May 6, 2021

**RE: Comments of Swan Lake and Goldendale
Puget Sound Energy – Final Integrated Resource Plan
UTC Docket UE-200304**

Figure 2: PSE Base Case Loss-of-Load Hours for 2027⁹

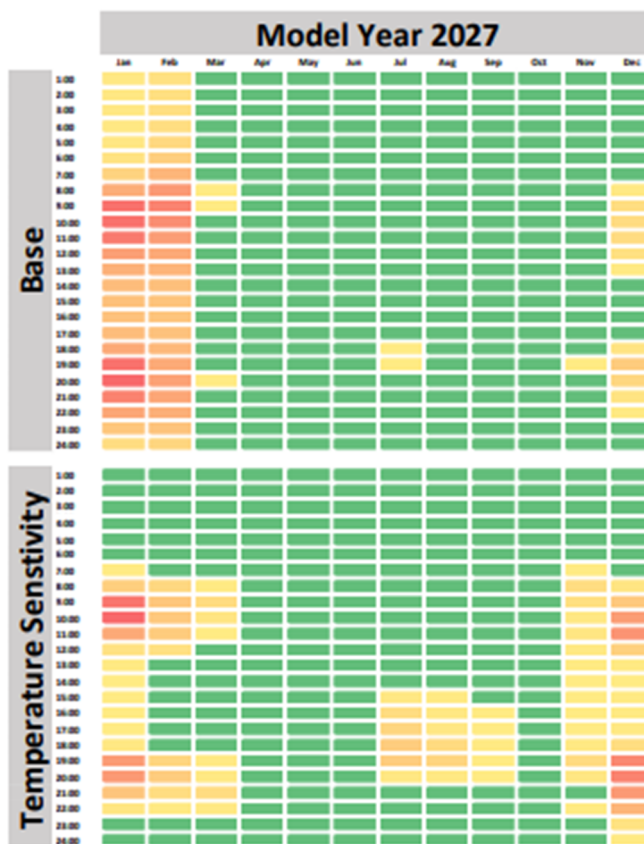
The first problematic assumption for storage resources’ ELCC values is PSE’s assumption that Loss-of-Load Events are 24-hours in winter months in 2027. For energy limited resources, such as energy storage, the availability of surplus energy and capacity in off-peak periods is key for enabling capacity service during on-peak periods. As is shown in Figure 2 below, by 2027, PSE’s base case forecasts that there will be 24-hour loss of load events in January and February (hours in which there is insufficient supply or wholesale market purchases available to meet load). The 24-hour loss of load assumption in January and February dramatically hinders the capacity capabilities that storage can provide to PSE since these energy limited resources are not allowed to charge in any hour of the day during these 24-hour Loss-of-Load Events and, as a result, the facilities are rendered unavailable because they have no modeled capacity available (*i.e.*, no charge). PSE has historically been a winter peaking system; however, peak needs have typically been during a few key hours (6AM-8AM/6PM-10PM) as opposed to the entire 24-hour time period.

Driving PSE’s first problematic assumption is the second assumption that negatively impacts storage resources—namely, assumptions around the availability of Mid-C wholesale purchases during the 24-hour loss-of-load period in January and February described above. In the Final IRP, PSE notes that they can only rely on 1,000 MW of wholesale purchases in January and February, contrary to the rest of the year where the assumed import capacity is closer to 1,400 MW.⁸ This

explains why December (an “on peak” month) does not show the same 24-hour loss of load profile that the January and February month does. It is unclear if the 1,000 MW wholesale purchase limit in January and February is constant across all hours of the day (peak and off peak), but it is clear that allowing additional market purchases in the off-peak night period would result in less 24-hour loss-of-load events and ultimately enable storage to provide more capacity services. It should be noted that, historically, there has not been market supply issues during off-peak periods, meaning PSE’s assumption about zero capacity being available in the wholesale markets (including from Mid-C) at night to charge storage resources does not align with historical data.

Figure 3: PSE Net Levelized Cost of Storage

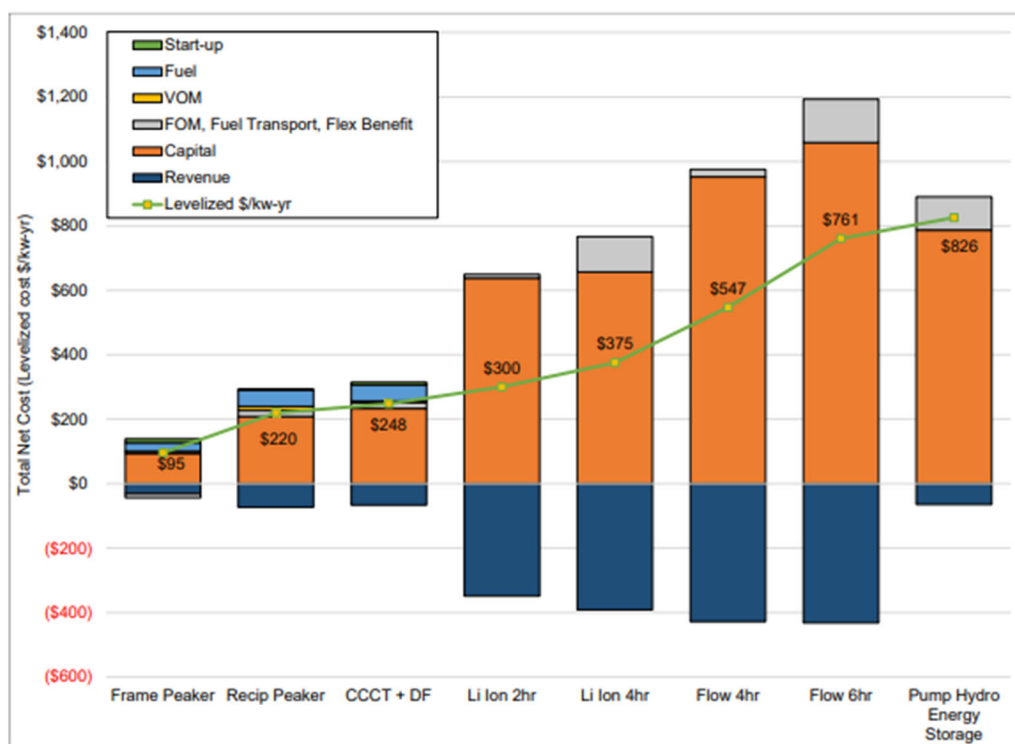
PSE's Final IRP also attributes storage resources, particularly pumped storage, an extremely high levelized cost, especially when compared with analyses conducted by PSE's peers and third-party, independent analysis firms. For example, the Final IRP indicates pumped storage has the highest net levelized cost of all storage technologies, and the least revenue attributed to it, when compared to other storage devices as shown in Figure 3 below.¹⁵ The revenue stack in Figure 3 is composed of energy services, flexibility, and transmission and distribution deferral benefits. The gap in revenue is puzzling, especially given that pumped storage has a higher roundtrip efficiency and duration than other storage technologies, such as flow batteries.

From a transmission and distribution (“T&D”) deferral perspective, PSE provides additional value to lithium-ion and flow batteries for flexibility in siting as opposed to pumped storage, which tends to be more geographically constrained. For the Final IRP, PSE utilized a T&D benefit value of \$12.61/kW-year for demand response and energy storage resources.¹⁶ Despite the supplemental benefit, the size of the T&D revenues is not sufficiently large to explain the revenue discrepancy seen in Figure 3 above.

Flexibility benefits of the various energy storage devices are also similar in size (\$/kw-year), but PSE’s results are non-intuitive and once again do not explain the storage revenue gap demonstrated in Figure 3. In PSE’s flexibility analysis, a 4-hr flow battery had a higher flexibility value (\$23.03/kW-year) than both a 4-hr lithium-ion battery (\$18.45/kW-year) and an 8-hr pumped storage device (\$18.41/kW-year), despite flow batteries having a lower round trip charging efficiency than both lithium-ion and pumped storage, and further despite the flow battery having less duration than the 8-hr pumped storage. Both pumped storage and lithium-ion batteries have sufficient ramping capabilities to optimize sub-hourly dispatch and, therefore, ramping constraints should not be causing this discrepancy in flexibility benefits, either. It is also worth noting that demand response—a resource typically limited to 4 hours of duration and 10 calls per year—is

Given that the discussion above eliminates T&D benefits and the flexibility benefits as potential reasons for the significant cost discrepancy shown in Figure 3, energy services is the only revenue stream that could potentially explain the puzzling gap in revenue between pumped storage, flow batteries, and lithium-ion batteries. Like the flexibility benefit discussion, it is not intuitive that flow batteries would outperform pumped hydro from an energy shifting perspective since flow batteries operate with lower storage duration (4hr-6hr) and worse round trip charging efficiency (73%).¹⁷ The 30% minimum pond constraint that is applied to pumped hydro in the PSE Final IRP, which is further explained above, could influence the energy value, but it is unclear whether this incorrect operating assumption alone is driving the large revenue gap that PSE is presenting in Figure 3.
